License Nos. DPR-39, DPR-47 and DPR-55
Appl for Amend: tech specs proposed change
concerning computer software currently
used to process the incore detector signal..
..notorized 1/3/78.....

PLANT NAME: Oconee Units 1-2-3
RJL 1/6/78

Re: Oconee Units 1, 2, and 3
Docket Nos. 50-269, -270, -287

OCONEE NUCLEAR STATION
Figure 2.3-2B

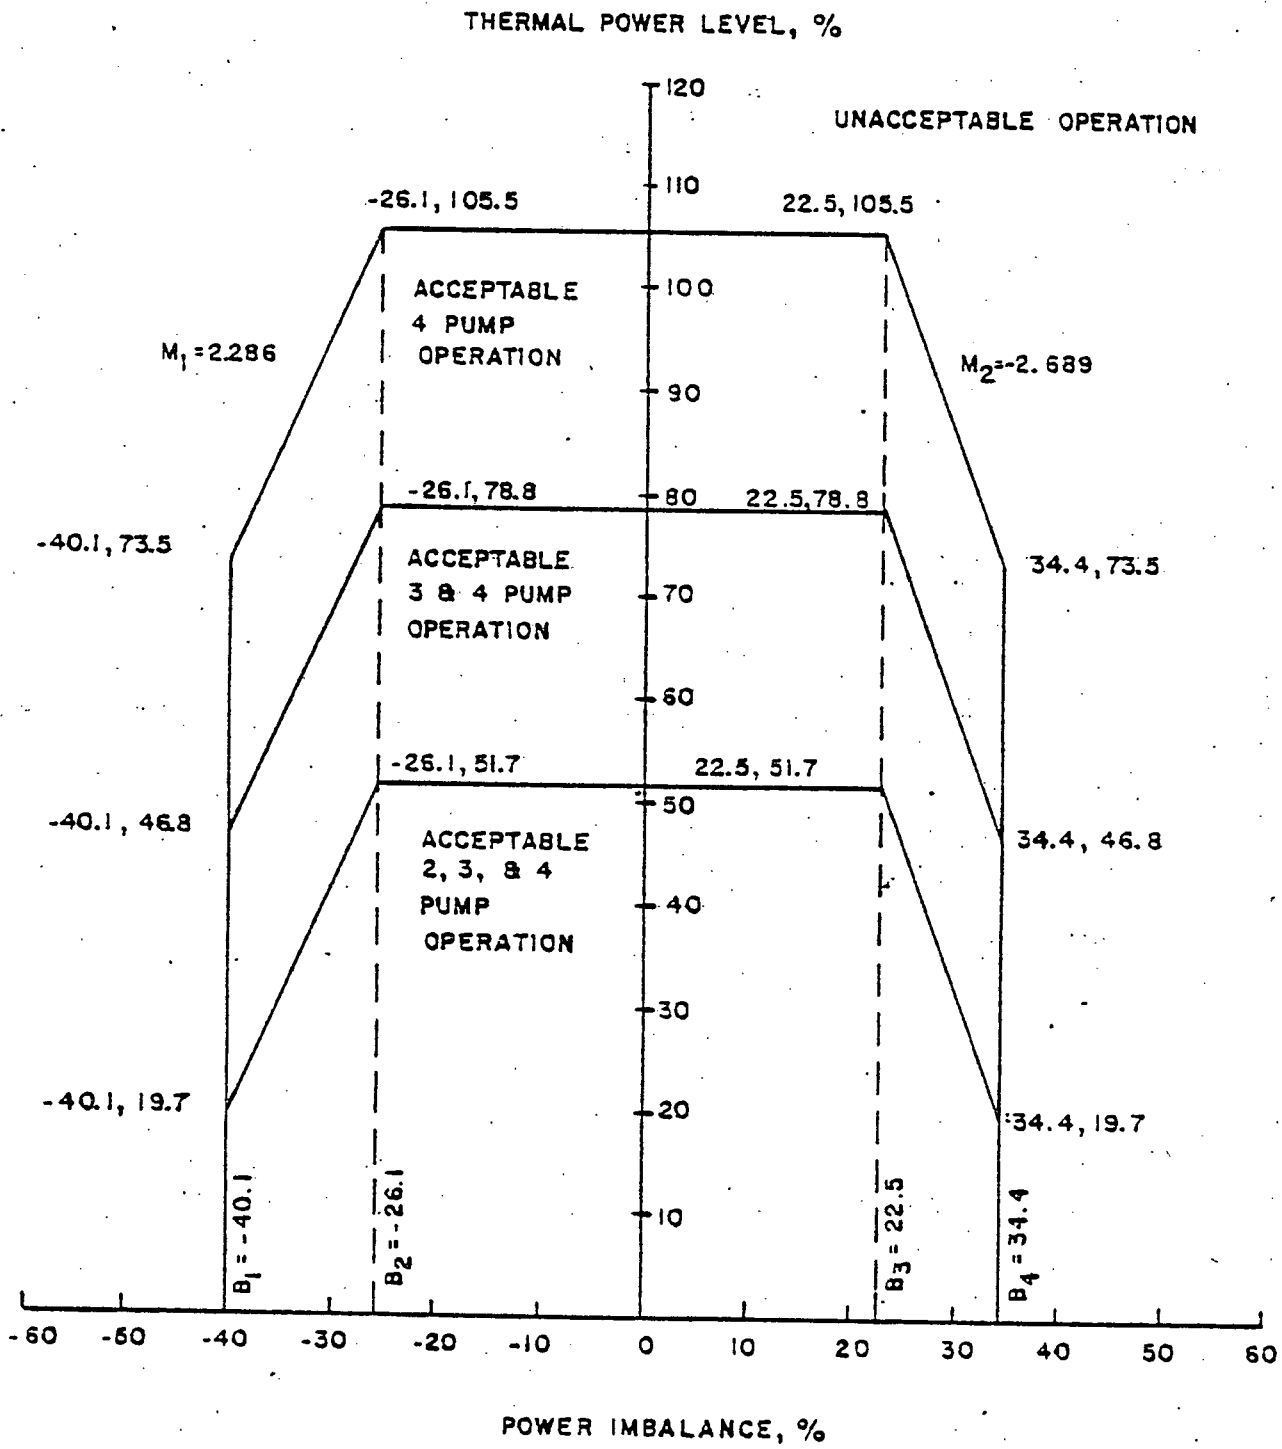
computer software is corrected for the proper background signal processing. Therefore, a revision of the Oconee Nuclear Station Technical Specifications is proposed herein pursuant to 10CFR §50.90. The attached proposed revision includes the modified power-imbalance trip setpoints for Oconee 2 and 3 (Technical Specification Figures 2.3-2 B and C) in order to account for the bias in the positive imbalance measured by the current incore detector system.

PROTECTIVE SYSTEM MAXIMUM
ALLOWABLE SETPOINTS
UNIT 2
